# **PRELIMINARY DRAINAGE PLAN PUD/SP 22-001**

## **HILLSIDE AT LORSON RANCH**

**JANUARY, 2022  
REVISED APRIL, 2022**

FOREBAY NO. 2 SECTION A-A  
NO SCALE

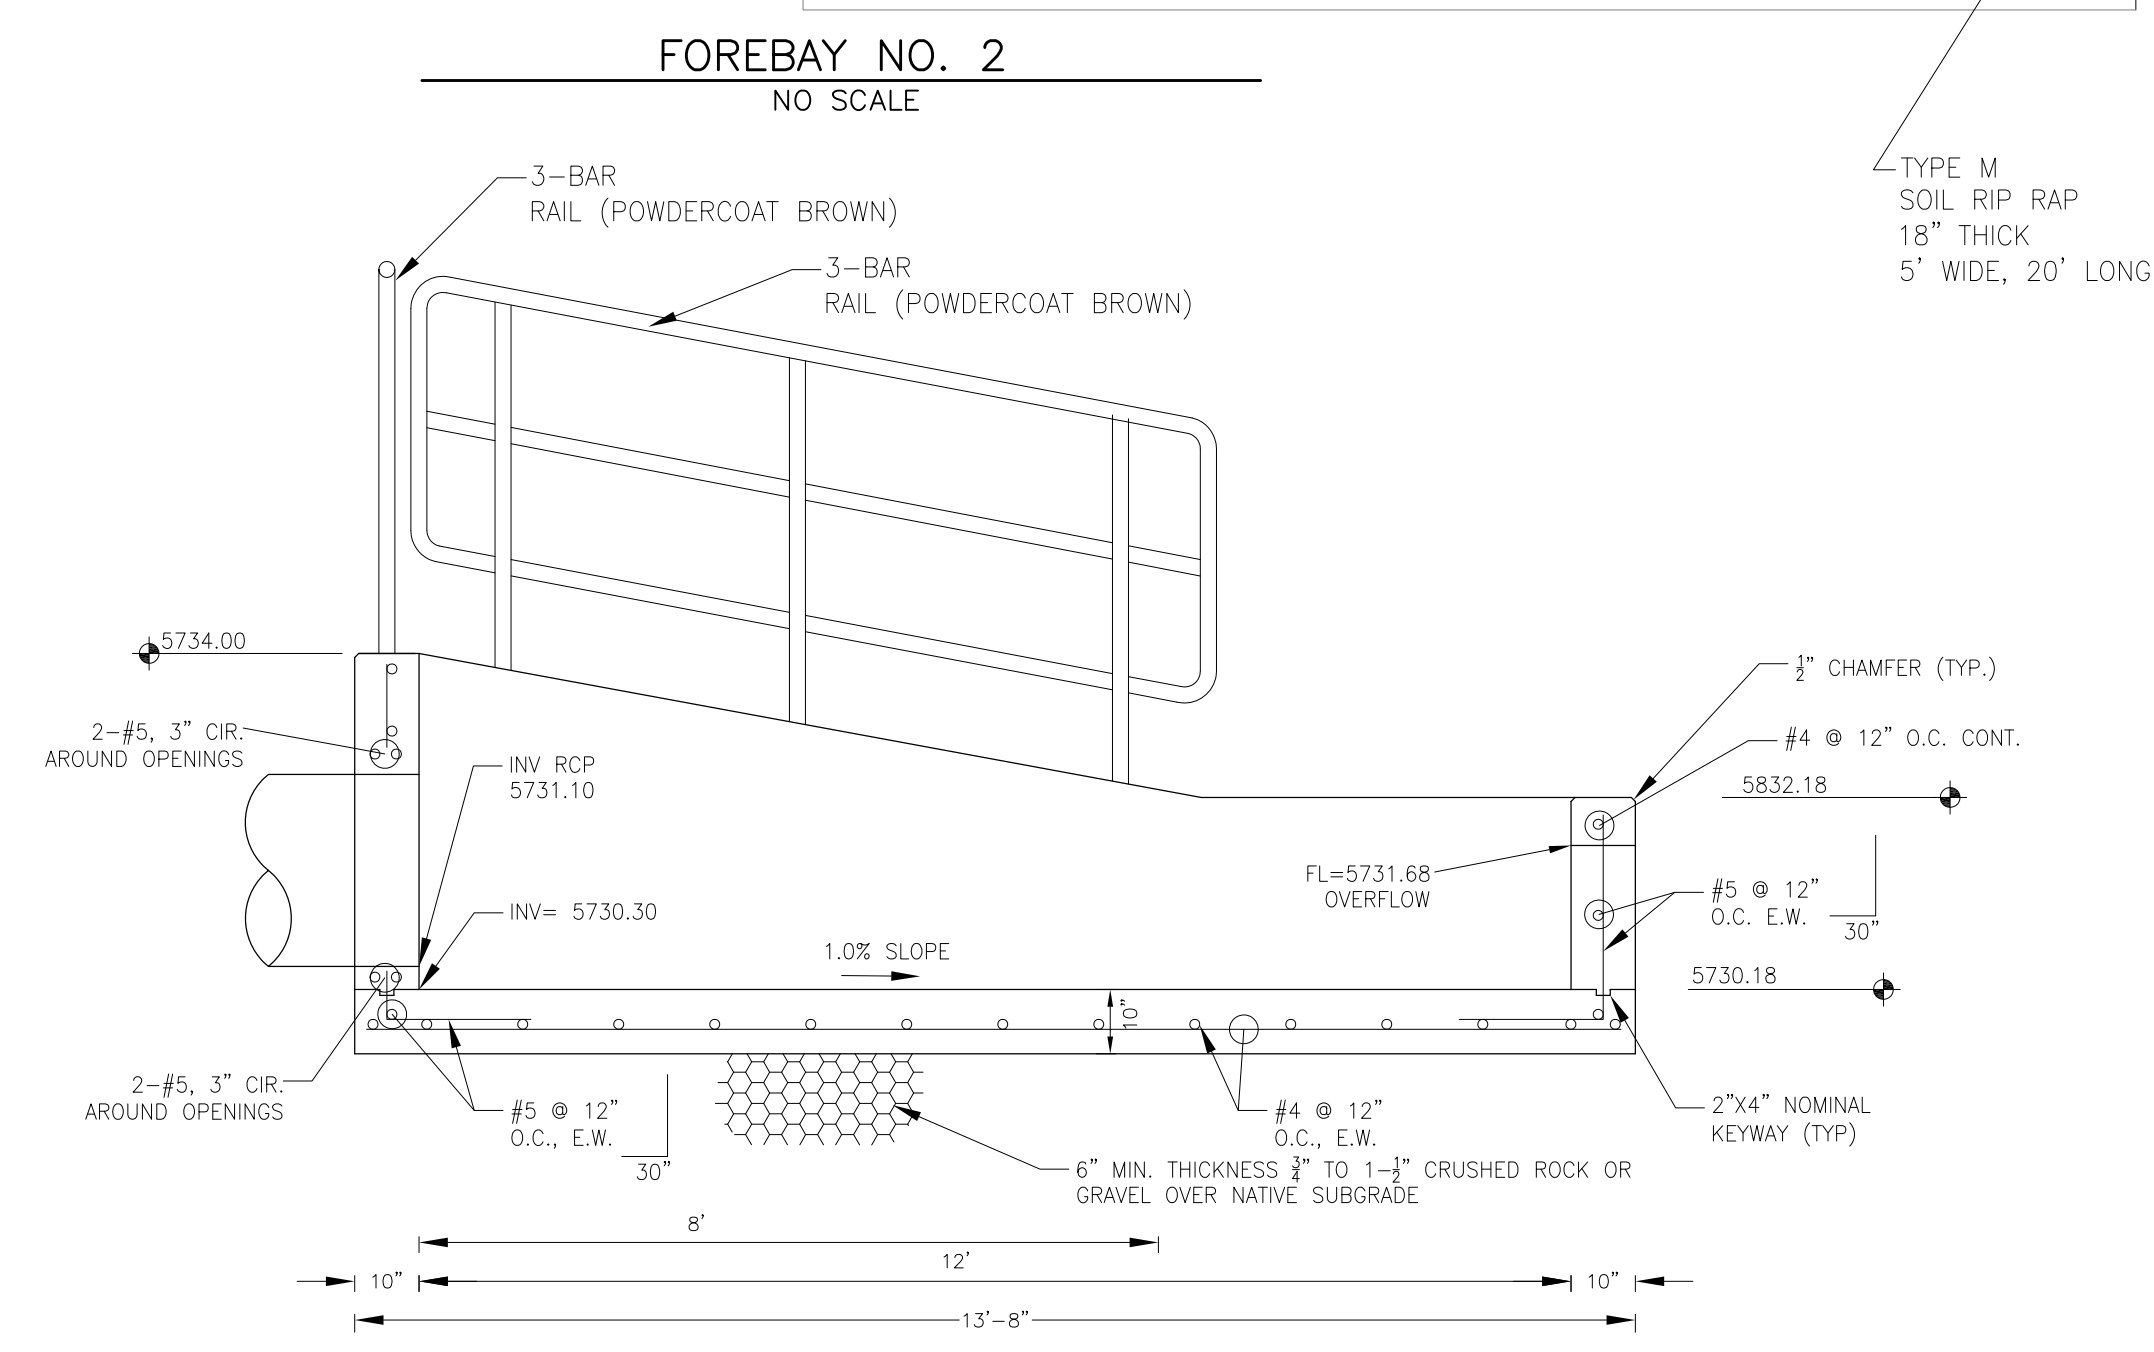
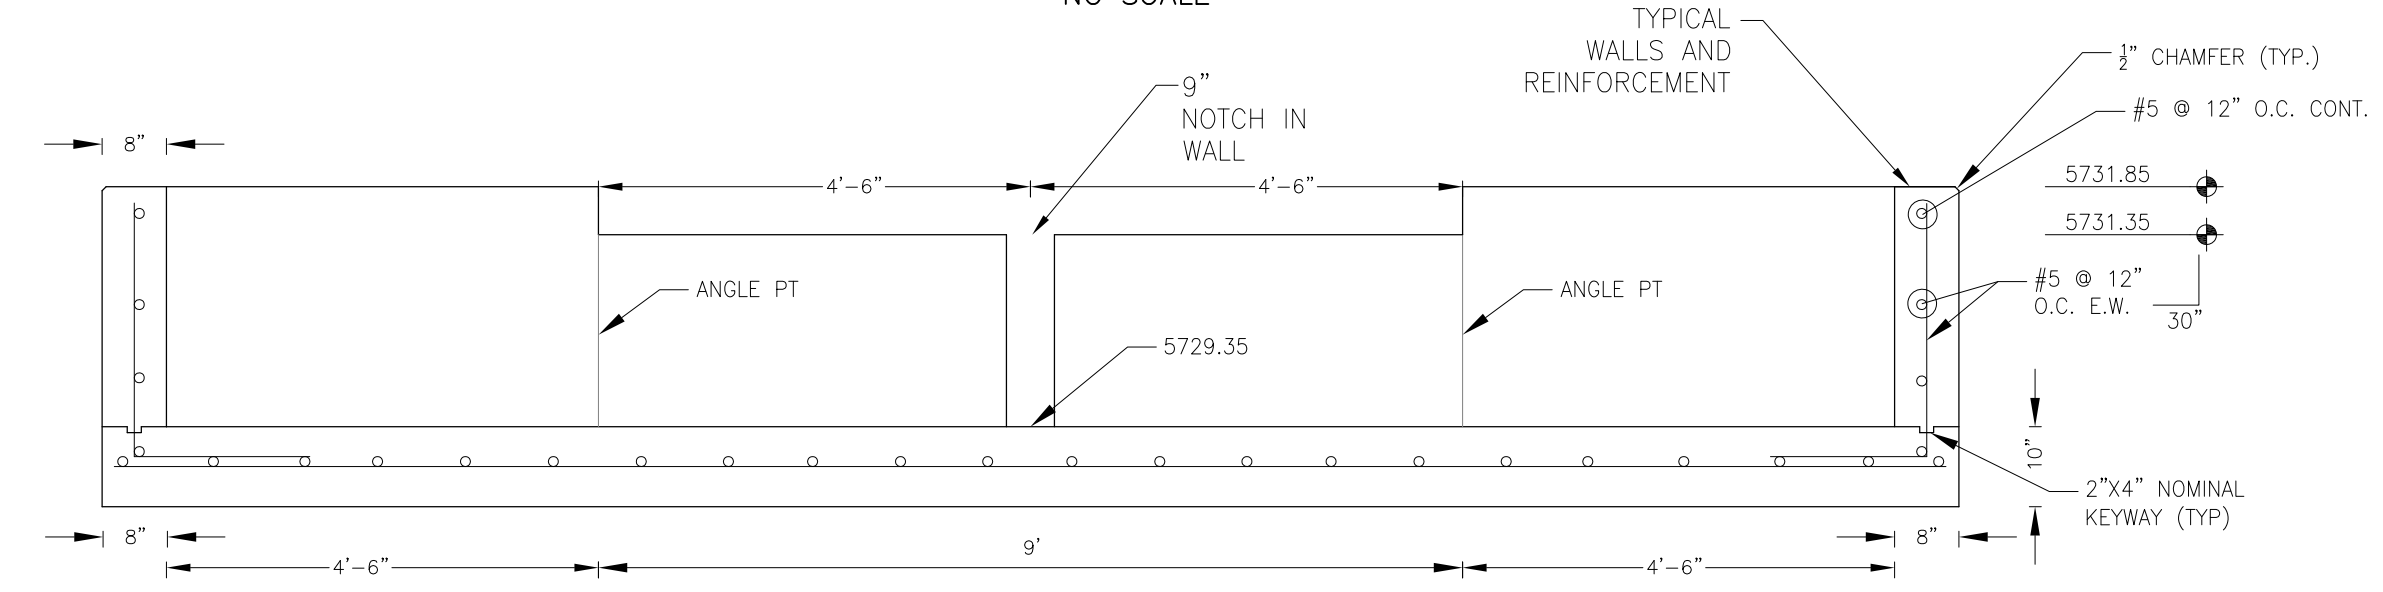
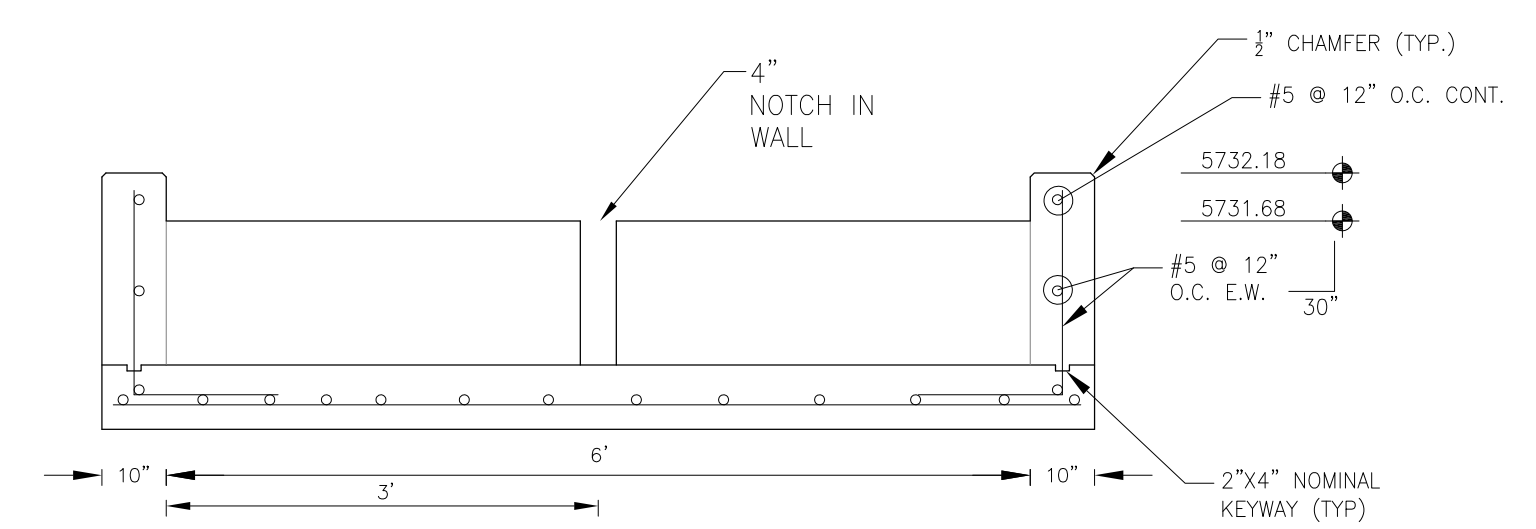
does not match what is shown on Sht C9.2 of GEC Plans. Revise to remove discrepancy.
